Docket Item #  
BAR CASE # 2009-0295

City Council  
March 13, 2010

**ISSUE:** Appeal of a decision of the Board of Architectural Review, Old and Historic Alexandria District, denying replacement of a slate roof with standing seam metal material.

**LOCATION:** 211 North Patrick Street

**Figure 13: Photos of roof with damaged slate.**

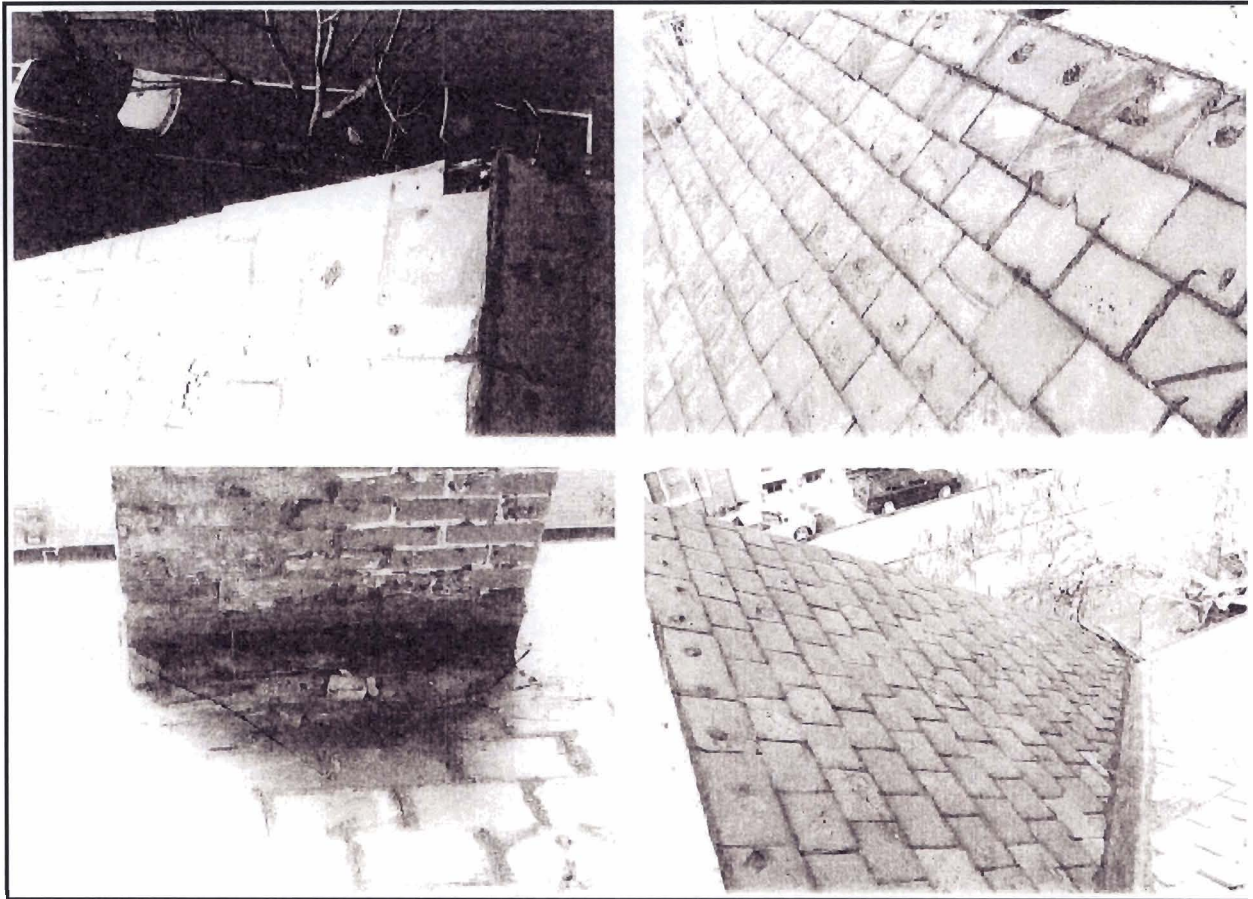
Staff believes that the applicant has demonstrated that the existing slate shingles are beyond repair, and that a new roof is necessary. The average live span of a slate roof is generally 60 to 125 years. Staff believes that the slate roof at 211 North Patrick Street is likely original to the construction of the house, making it approximately 120 years old. The applicant has provided a number of photographs which show significant damage due to cracking and spalling. The National Park Service’s Preservation Brief 29, *The Repair, Replacement & Maintenance of Historic Slate Roofs*, strongly encourages the retention of historic slate and repairing where needed. The NPS brief states that: “If 20% or more of the slates on a roof or roof slope are

broken, cracked, missing, or sliding out of position, it is usually less expensive to replace the roof than execute individual repairs.” The percentage of damage to individual slates appears to exceed 20% at 211 North Patrick Street.

**Figure 16: Photo simulation of house WITH METAL ROOF**

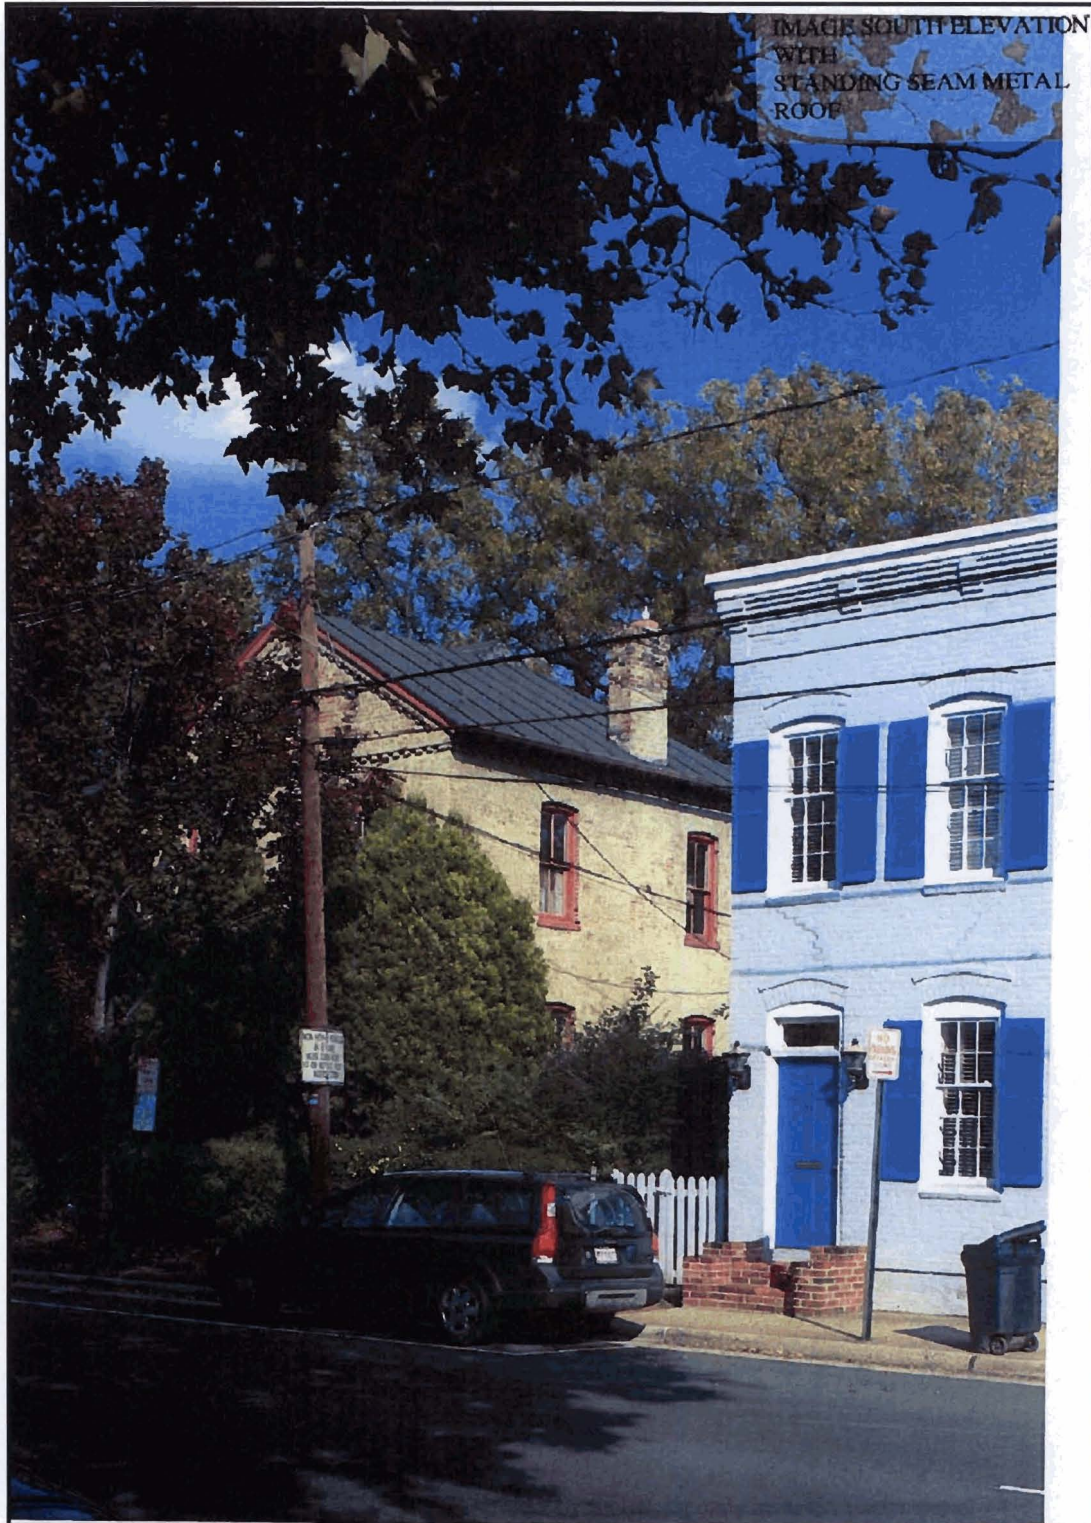
Instead of slate material, the applicant has proposed black colored, prefinished aluminum standing seam roofing. This has an appearance similar to historic metal roofing but is a modern system and is neither the material or installation method used on late 19<sup>th</sup> century metal roofs. Historic roofs used rolls of tin-plated iron with soldered seams and were field primed and typically painted an oxide red color. The factory applied finish of the modern aluminum roofing does not allow it to be soldered. It is simply caulked at vent penetrations, valley intersections and chimney flashing. Because caulk is not as reliable as soldered seams over the long term, some reputable roofing companies will not install this system on roofs with complex hips and gables, as on the subject house. Although prefinished metal roofs are routinely approved by the Board or staff as historically appropriate replacement for metal or composition shingle roofs on a simple side gable townhouse, it is neither the architecturally appropriate material to use on the complex roof form at 211 N. Patrick, nor historically authentic to this building.

The applicant argues that a replacement metal roof is historically appropriate. While metal roofs were available and widely used during the late 19<sup>th</sup> century when the house was constructed, the use of slate is also relatively common for Queen Anne masonry houses. Another local example of a Queen Anne house with a simple, unadorned slate roof is the French-Lawler house at 517 South Washington Street. The house at 211 North Patrick Street was constructed in a higher style than other houses in the neighborhood and using new slate will help to retain this distinction. As a freestanding building in the Queen Anne style, this building has one of the more complex roof forms found in the district, and with the retention of many of its original features, the house is rather remarkable in the district. The use of individual slate shingles complements the detail and complexity of the roof design; the use of standing seam metal would compromise the integrity of this character-defining feature and the building as a whole. Therefore, Staff finds that the new roof should be slate, matching the size and color of the original and not standing seam metal as proposed by the applicant.

**IV. STAFF RECOMMENDATION:** Staff recommends denial of the Certificate of Appropriateness to remove the existing slate roof and install a new standing seam metal roof and approval of authentic slate shingles in the same dimensions, color and pattern to match the existing historic roof to the extent possible.
